ADDENDUM NO. 3

City of Tukwila, Washington S Boeing Access Road over Airport Way Bridge Seismic Retrofit Project

City Project No.: 91310407

DATE OF ADDENDUM ISSUE: March 31, 2020

C7

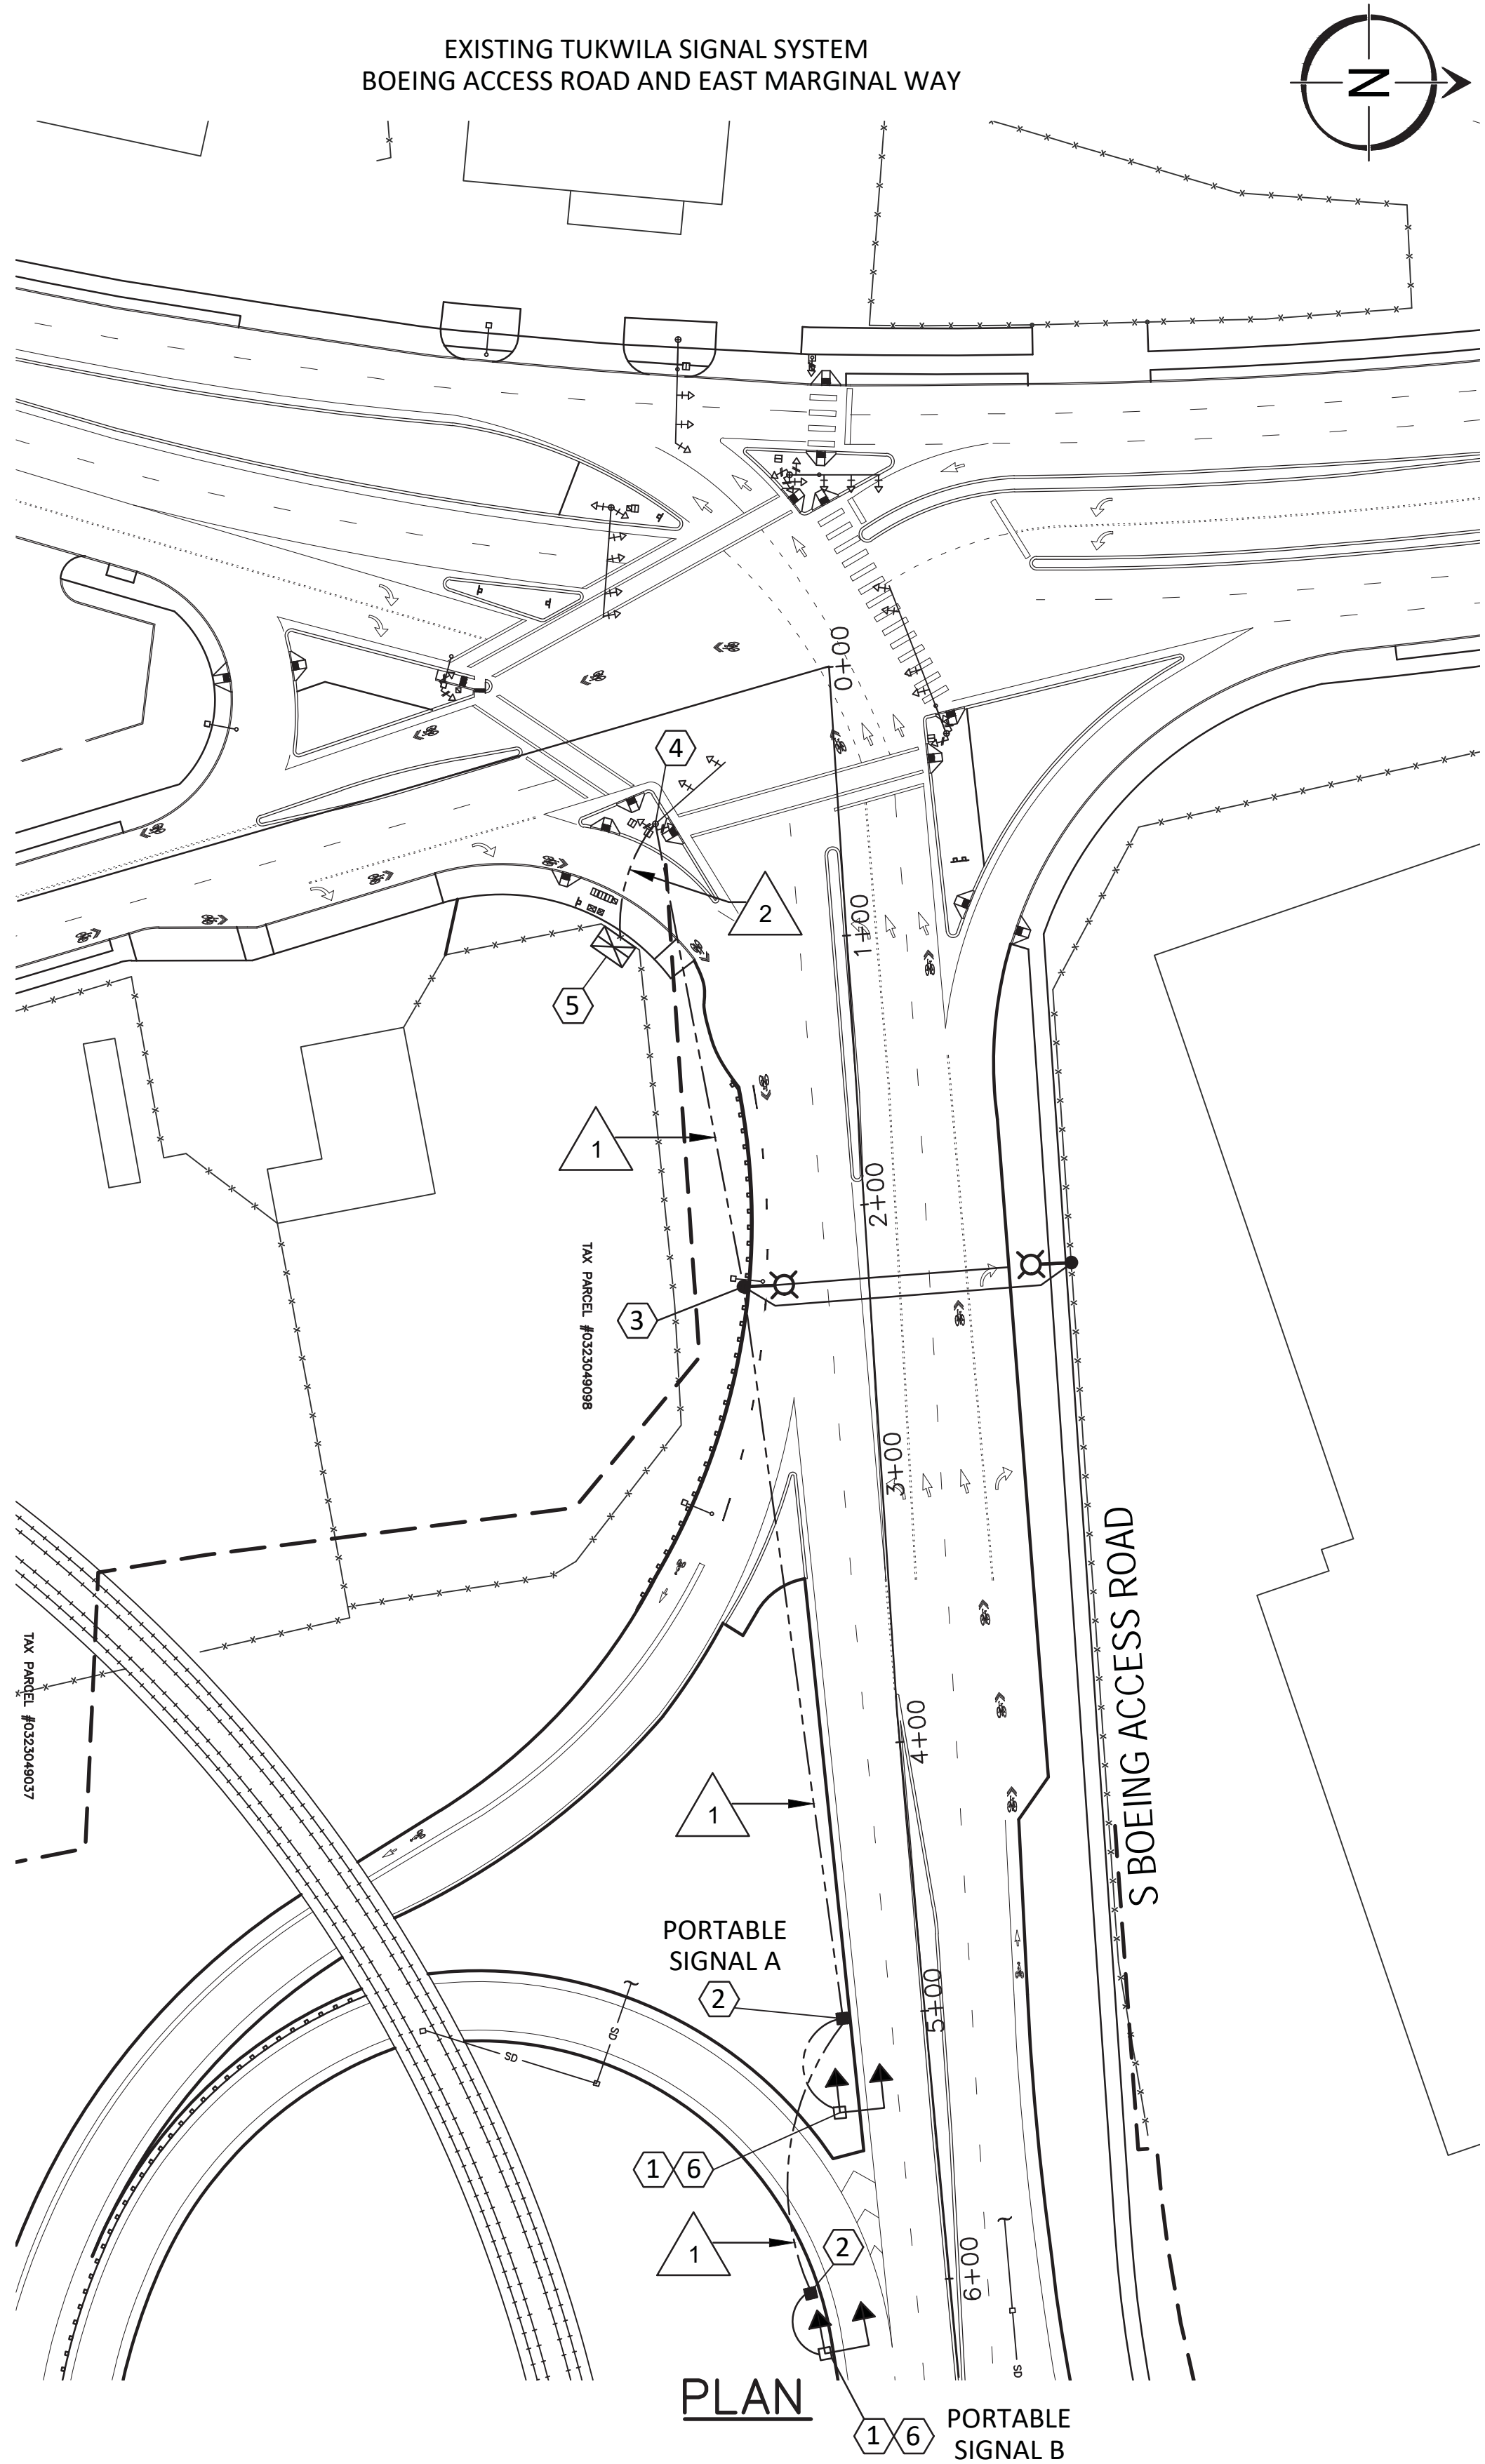
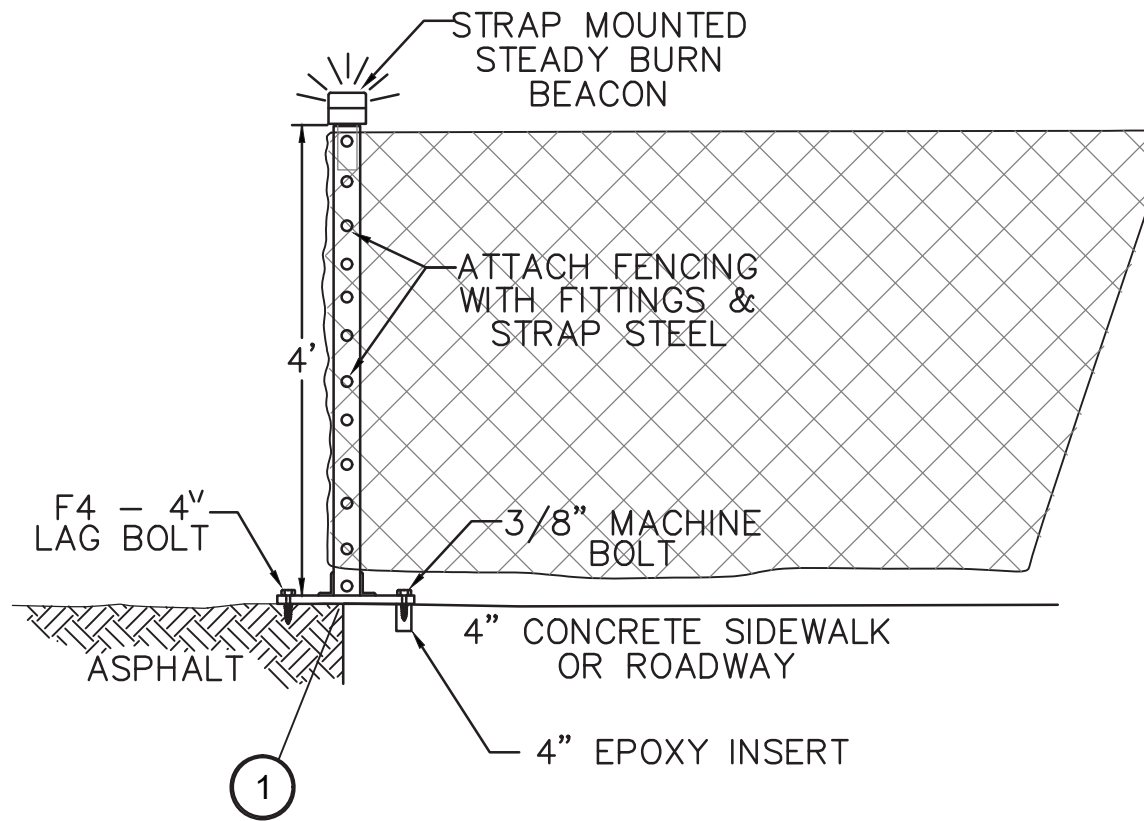
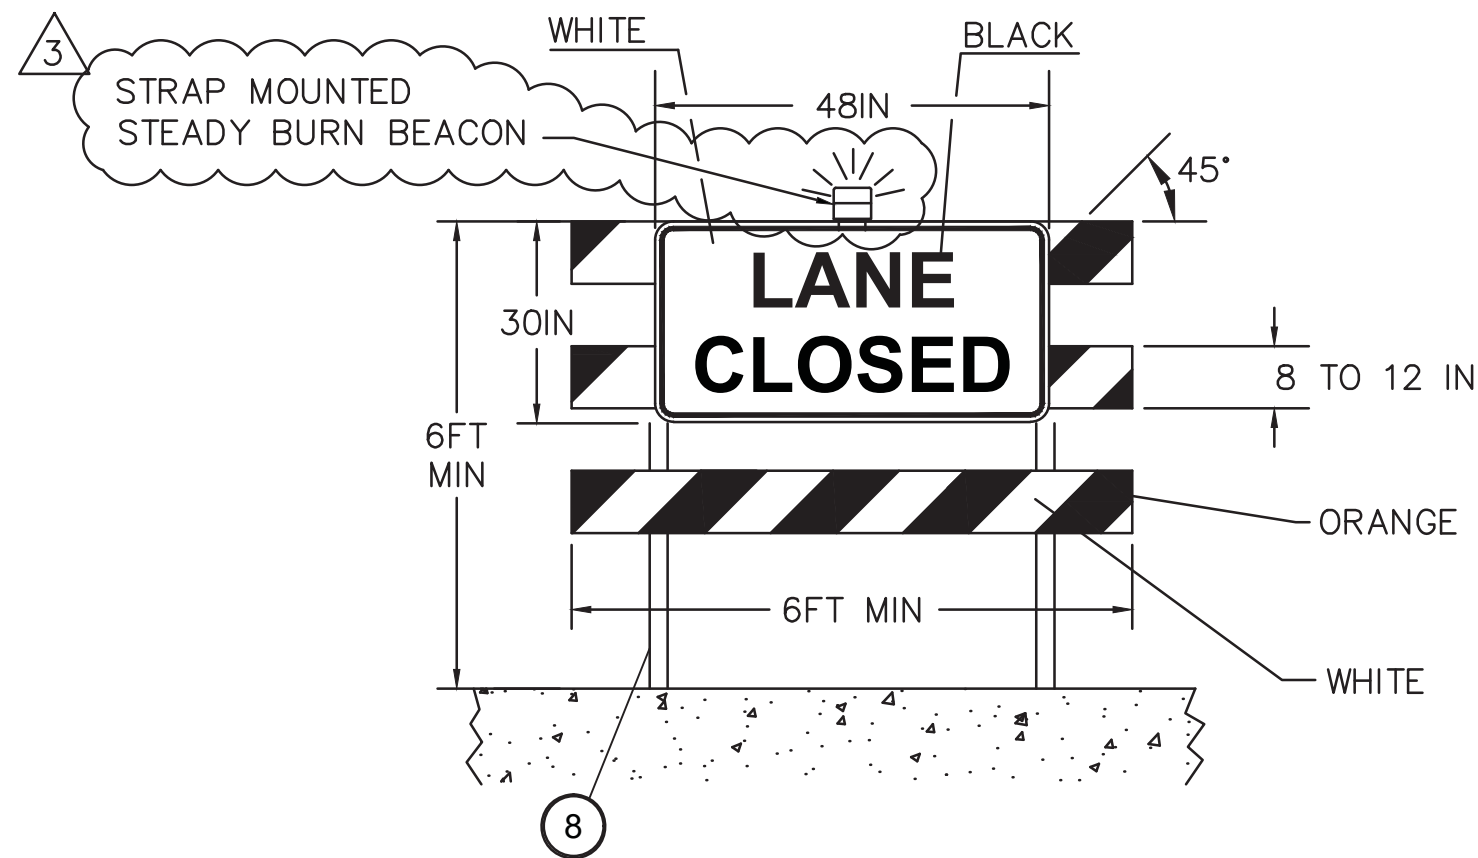
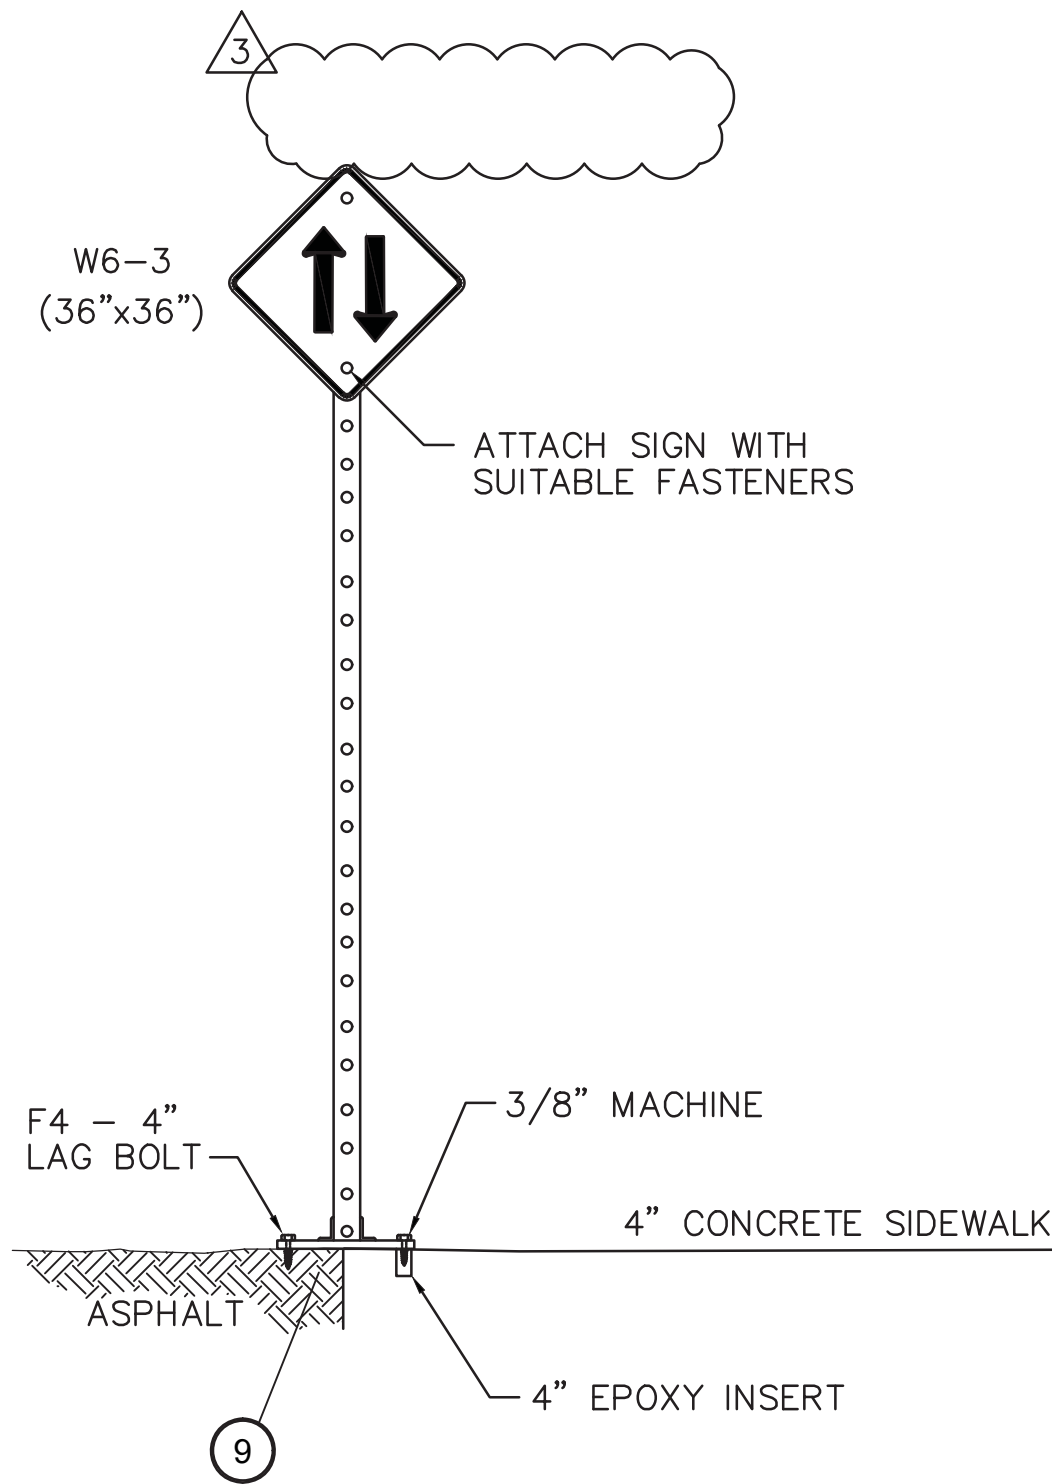
6. Plan Sheet 10 of 23:

DELETE Sheet 10 of 23 and REPLACE with the attached Sheet 10 of 23.

The following changes have been made:

- Removed sand barrel with sign.
- Revised Detail B to include beacon.
